# MSEX3054A-01

## S E R V I C E N O T E

MSEX3054A – Oscilloscope, Mixed Signal, 4+8 Channel,  
500MHz

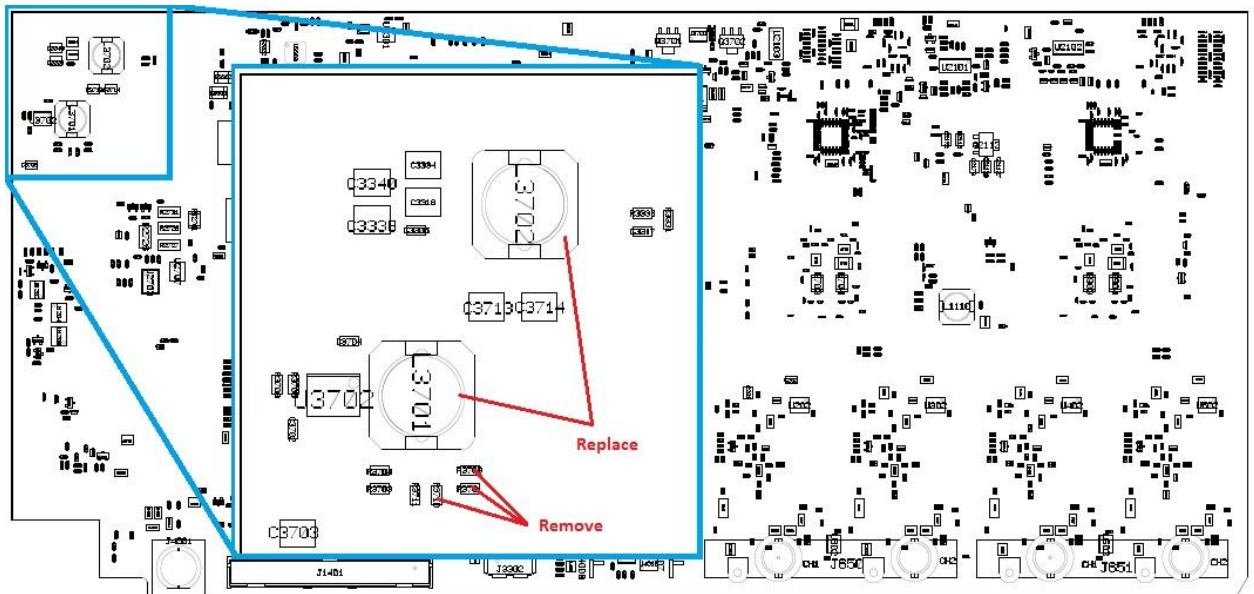
With the oscilloscope power turned on and while under normal operation, the unit emits a hissing noise.

2. As the picture indicates, remove the three resistors (0699-7209, 1 Ohm) located at R3701, R3709, and R3710. They are not to be replaced.
3. Remove as well the two inductors (9140-6474, 100uH) located at L3701 and L3702 and replace them with inductors with part number 9140-6151 (68 uH).
4. Re-assemble to the point where the unit could be powered up to verify that the hissing is indeed gone. If the hissing is not gone, please, check modifications.
5. When the hissing is gone, put oscilloscope back together.
